529 Congress Street

Subject: Rines Brothers Company
Store Alterations
Portland, Maine

DETAILS AT TOPS OF CONGRESS ST. COLUMNS

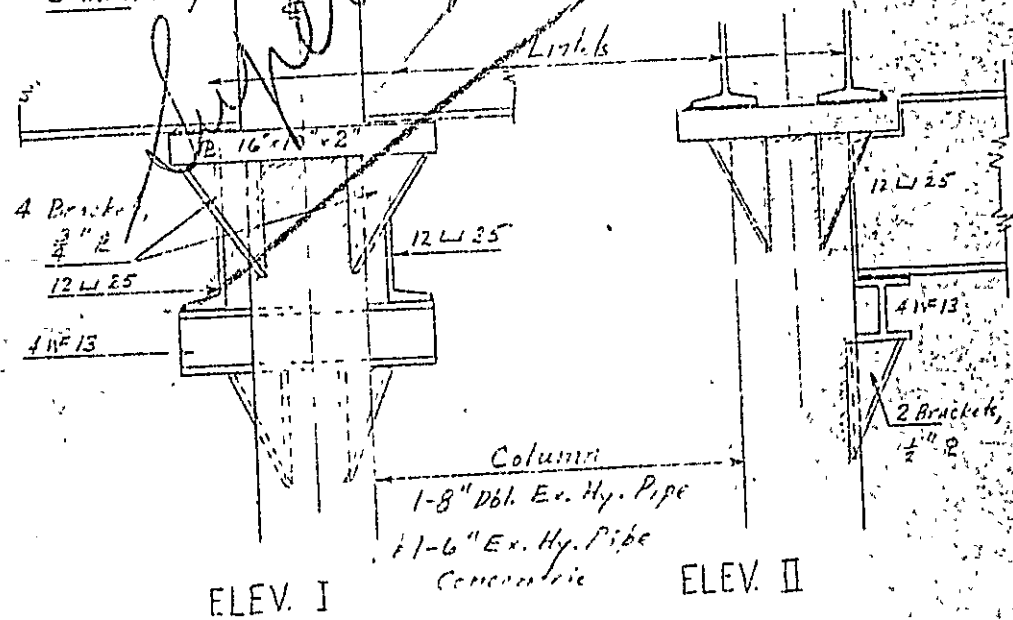
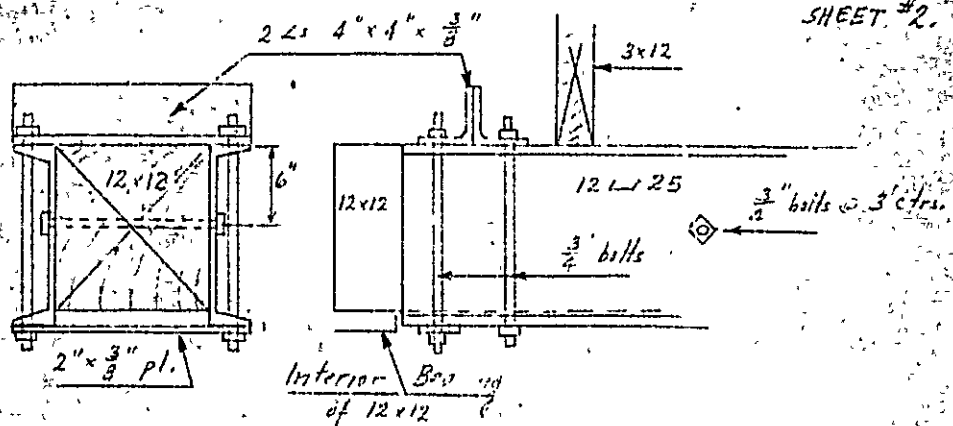
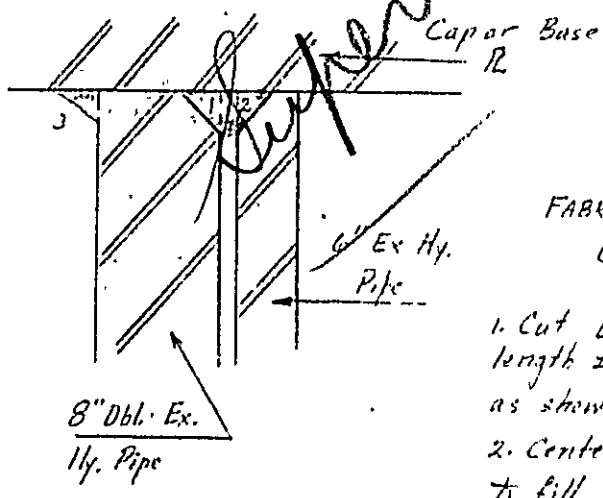
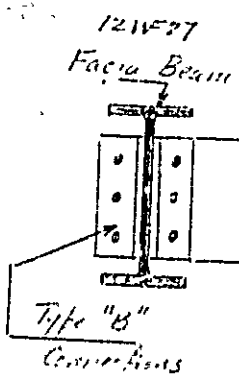
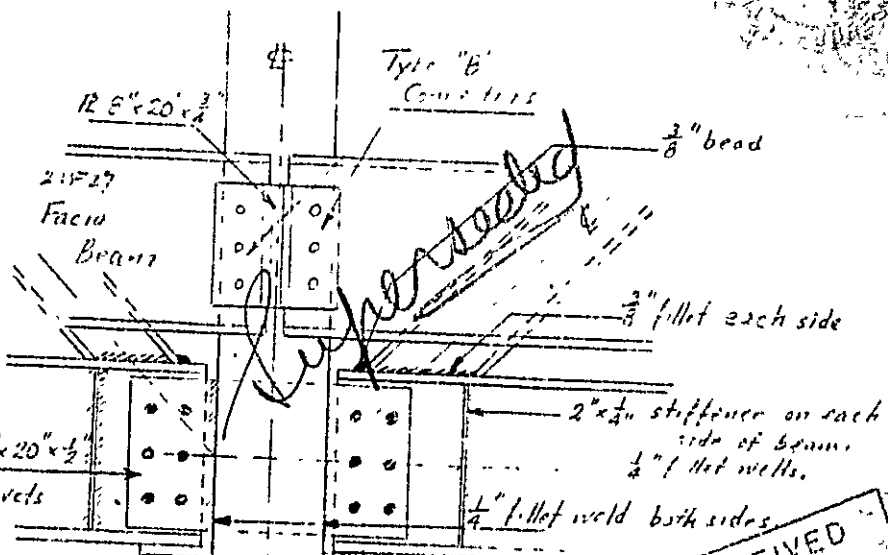
The bracket shown on sheet 1 for supporting the cap plate under the lintel beams and for supporting the channels, which in effect replace the 12x12 timber, may be placed in slots or simply welded to the outside of the outer column section. Owing to the continuity between the inner and outer columns established by the cap plate and the welding of the ends of these two columns together, I believe that the eccentricity of the load from the pair of 12" channels would be transmitted to a certain extent to the inner column as well as to the outer one.

The 12 x 12 appears to end about 20" short of the centerline of lintels. The detail shown on this sheet for transferring the 12 x 12 reaction to the column is not capable of transmitting any significant bending moment. Therefore, the pair of channels must act as a cantilever from the column and should be connected to the column in a way which will accomplish this. Using Mr. Mallon's reaction of 19^k , the moment at the column centerline is $19^k \times 24" (+) = 456^k \pm$ compared with his assumed moment of $19^k \times 7-1/2" = 142.5^k$ given on his sheet #4. It seems to me that if the reaction of the 12 x 12 is not to create a moment in excess of 142.5^k at the column then the connection between the 12 x 12 and the pair of channels must be designed to transmit a bending moment of about 450^k . The detail shown would not appear capable of safely transmitting more than a small fraction of this.
